January 29, 2021

RE: Safety Review of Camp Meeting Road
Citizens for a Great School / Quaker Valley High School Relocation
Leet Township, Allegheny County, Pennsylvania

French Engineering was engaged by the Citizens for a Great School to review the impacts of the proposed relocation of Quaker Valley High School to Camp Meeting Road in Leet Township, Allegheny County, Pennsylvania. At this time, the traffic study is still being prepared by the school district. In the interim, a review of potential safety concerns was conducted for Camp Meeting Road between the proposed high school and Beaver Street, as these concerns may have some bearing on special exception criteria, particularly:

C. Inadequate sight distance on select horizontal curves on Camp Meeting Road

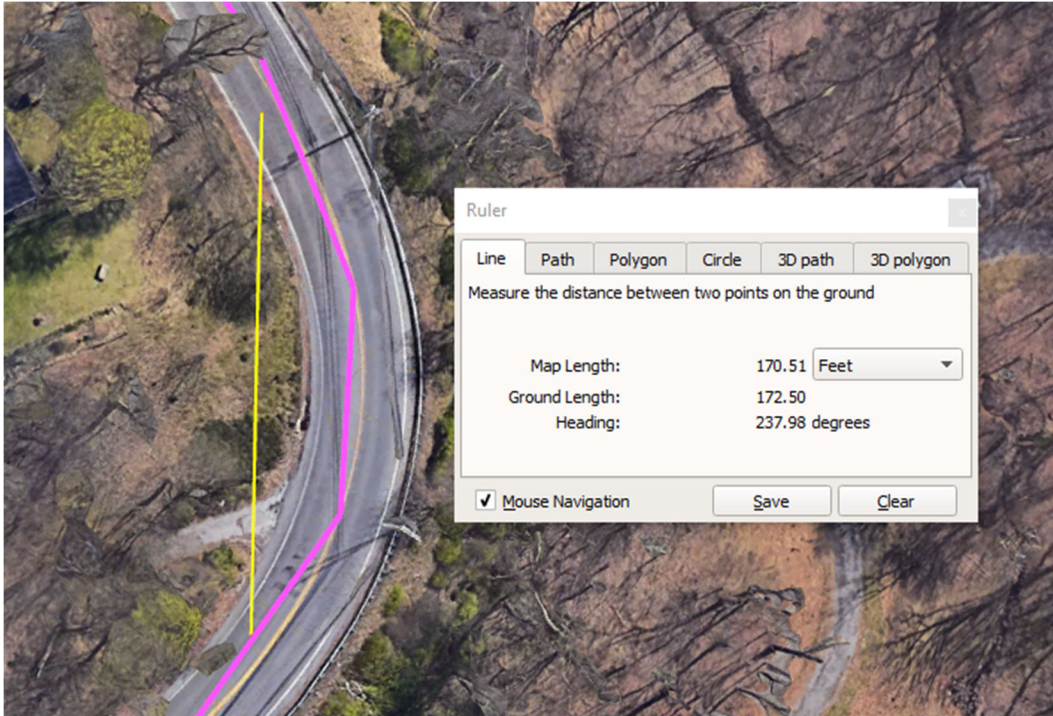
According to the Policy on Geometric Design of Highways and Streets, Table 3-2 Stopping Sight Distance on Grades, the stopping sight distance for 25 mph speeds on 9% grades are as follows:

Upgrade = 140-ft

Downgrade = 173-ft

There are multiple examples along Camp Meeting Road where these minimums are not met because of embankments and / or vegetation on the inside of horizontal curves obstructing visibility. The consequences of inadequate sight distance are an increased risk of hitting objects in the road, including other vehicles, such as those that might be moving slow or queued due to congestion.

The following three figures illustrate this point. The first is an aerial photo that shows a measured distance of 173-ft being blocked by a wall / embankment. The final two are photos taken from ground view upstream of horizontal curves with sight distance limited by obstructions on the inside of the curve.

Excerpt from PennDOT Roadside Safety Pocket Guide showing 2-ft minimum distance between the back of the guide rail post and the top of slope on embankments.

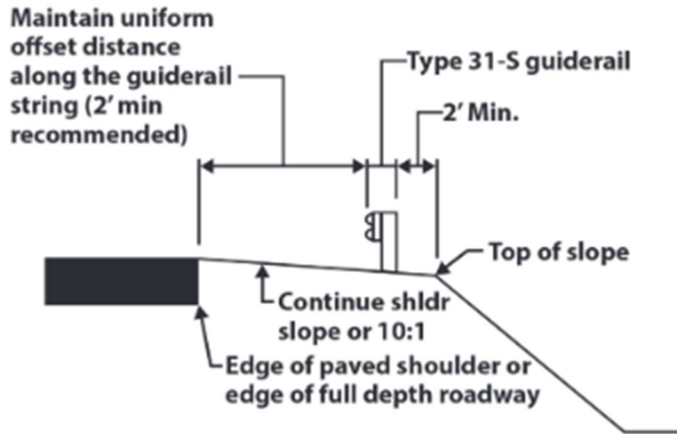
With respect to sliding guide rail, it should be noted that there should be 2-ft of somewhat level earth behind the guide rail posts to secure them in the ground. This is not likely to be present throughout, especially if the posts are sliding.

In addition, there should be a clear area behind the guide rail posts that is at least equal to the deflection distance of the guide rail. Without a detailed examination, of the guide rail, it will not be possible to know the deflection distance. According to the PennDOT Roadside Safety Pocket Guide, deflection distances range from 1.5-ft to 9-ft. It is likely that there are obstructions, namely utility poles and trees, within the deflection distance of the guide rail that has been installed.
